TECH NOTE

AUTOMOTIVE – TIMING SYSTEM

INSTALLATION RECOMMENDATIONS FOR TIMING BELT SYSTEM ON HONDA 1.7L ENGINES

BULLETIN: TSB008_AU

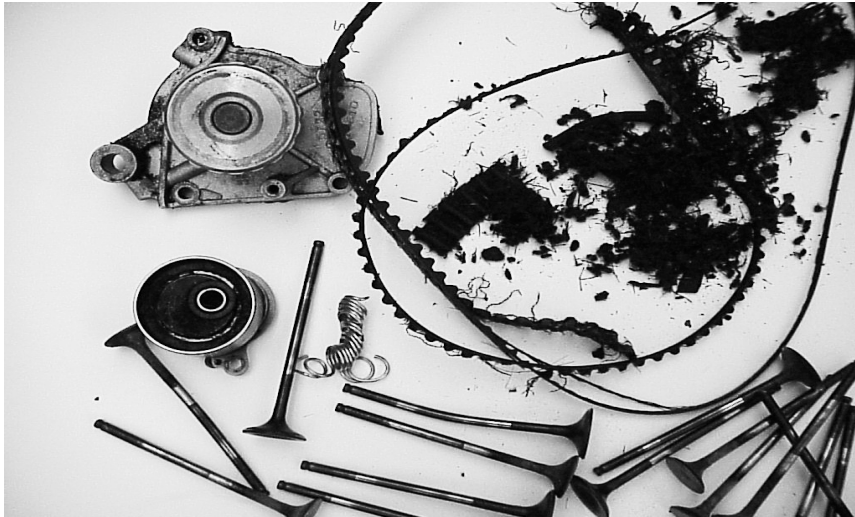
Below is the result from improper belt setup. Notice the damaged spring, this is the result of turning the crankshaft clockwise during initial setup, which is incorrect.

Crankshaft must be rotated two turns **COUNTERCLOCKWISE** with locking pin in tensioner and attachment bolt loose. Not following proper installation procedures will cause:

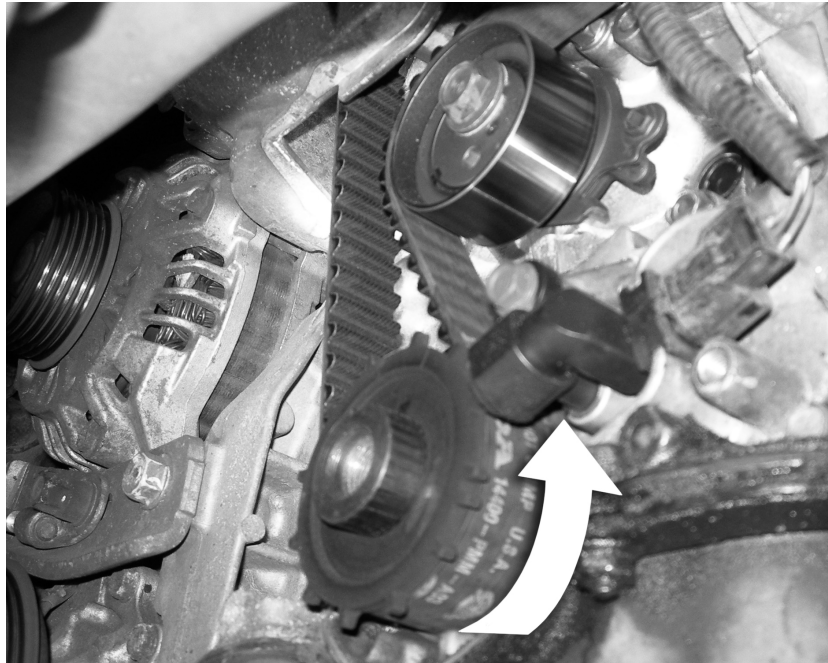
During setup attention needs to be given to the relationship of tensioner spring. The spring must be in the “UP” position which is noted on the spring rubber dampener.

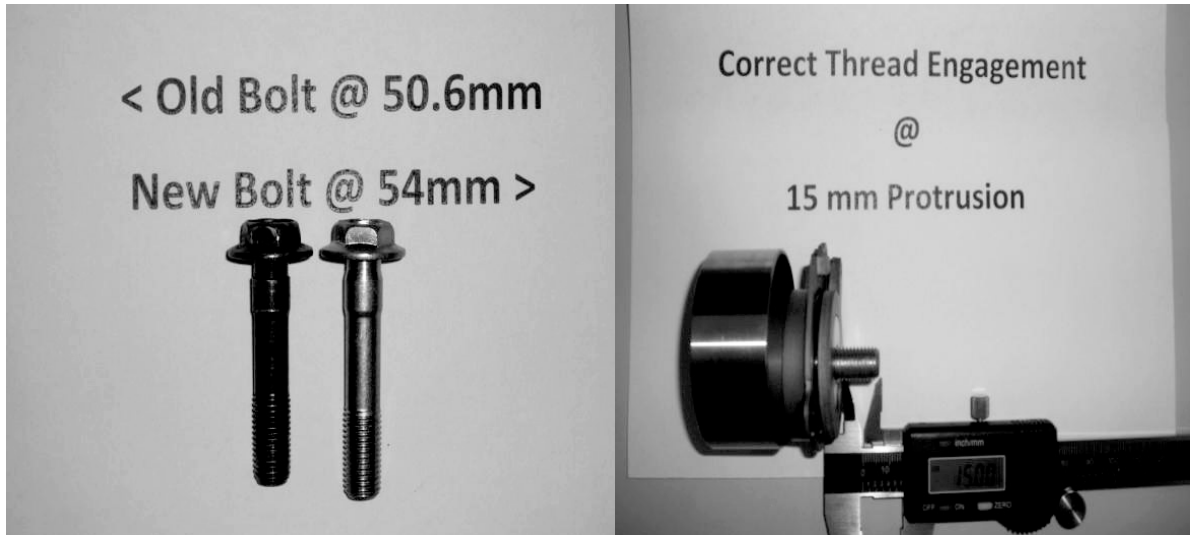
2001 – 2003 model years may require a longer fastening bolt!

Please be advised that early model year Civics may require an updated tensioner bolt. Honda upgraded the timing belt tensioner assembly in late 2002. Gates Tensioner follows the design change. During this change the OE bolt length was also changed to allow for proper thread engagement. Gates supplies the updated bolt as part of TCK312 Kits.

Verify this issue with one of the following procedures, the updated OE tensioner and bolt has been provided in this kit.

1. With tensioner fastening bolt placed through tensioner assembly – Verify there is 15mm of thread engagement.
2. Measure Bolt: Bolt length for new tensioner design provided in this kit should be 54mm in length.

(Incorrect Bolt Length Is 50.6mm).
